### भारत सरकार Government of India विद्युत मंत्रालय Ministry of Power उत्तर क्षेत्रीय विद्युत समिति Northern Regional Power Committee

## विषय: संरक्षण उप-समिति की 54 वीं बैठक की कार्यसूची | Subject: Agenda for 54<sup>rd</sup> Protection Sub-Committee Meeting.

## 54<sup>th</sup> Meeting of Protection Sub-Committee (PSC) of Northern Regional Power Committee

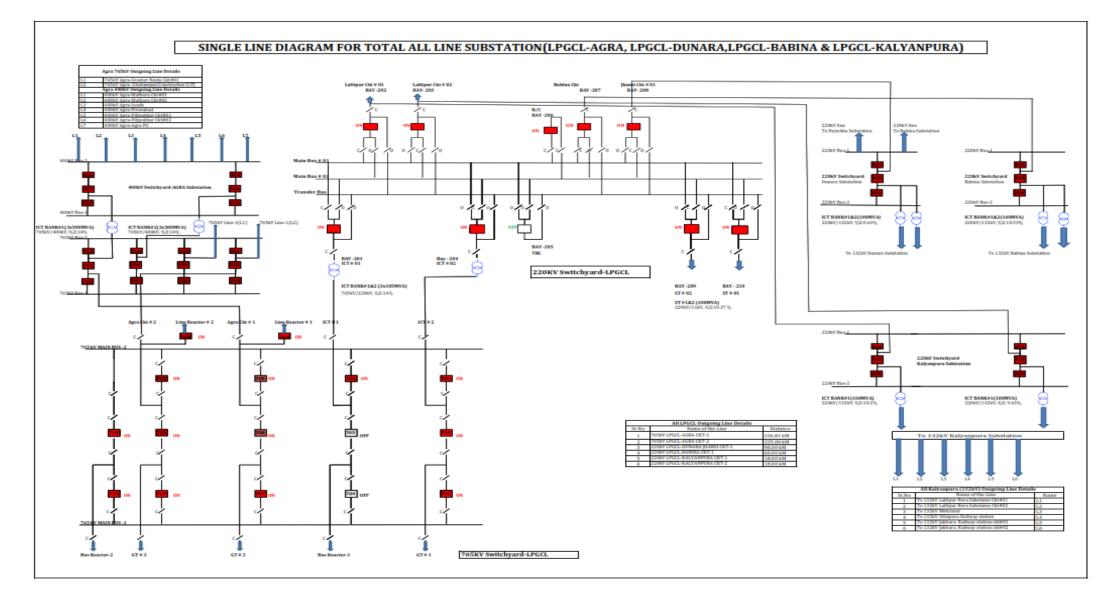
- The distance protection Main-I and Main II ,of all Zone's impedance reach setting for 765KV Lalitpur-Agra/Fathehabad Ckt#01 & Ckt #02 lines are requires some minor revisions.

- The distance protection Main-I ,Zone 1 impedance reach setting for 220KV Lalitpur-Dunara Ckt#01 lines are properly set and some minor revisions are required in Zone 2 Zone 3 and Zone 5 impedance reach settings.

### TABLE 32: REMARKS AGAINST TOR POINTS FOR AMGURI RE PLANT

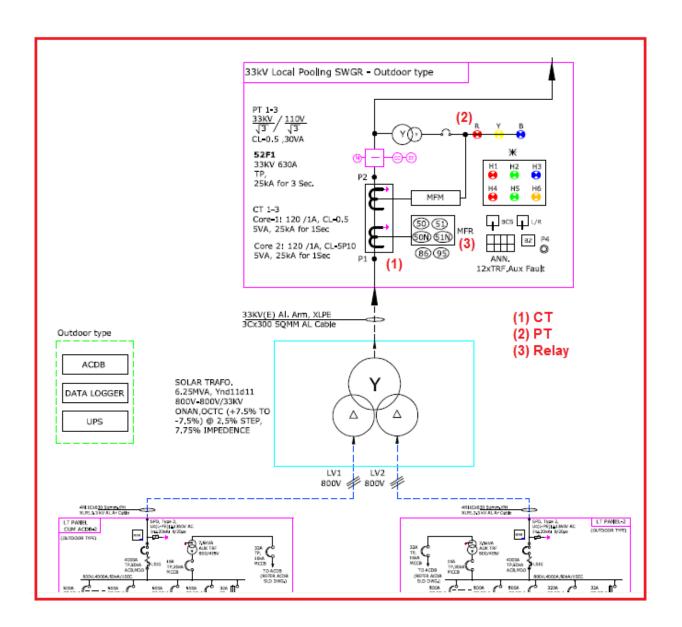
### **Observations and suggestions forwarded by FOLD Working Group 3**

- 1. As per conversation with M/s Jackson, the status of protection functions, grid support features for the inverters etc. are inbuilt within the same inverter module. There is no provision of separate IEDs to monitor the protection functions. Hence, the DR recording facility (in comtrade format as applicable at Generating Stations and Transmission substations) is not applicable to the solar plant inverters at Amguri.
- The protection at stepped up voltage at 220kV Level at Amguri Plant is as per the protection philosophies followed by other transmission utilities. Hence, the main area of concern is post-fault monitoring of analog values and digital status at inverter level (DC side and AC Side)
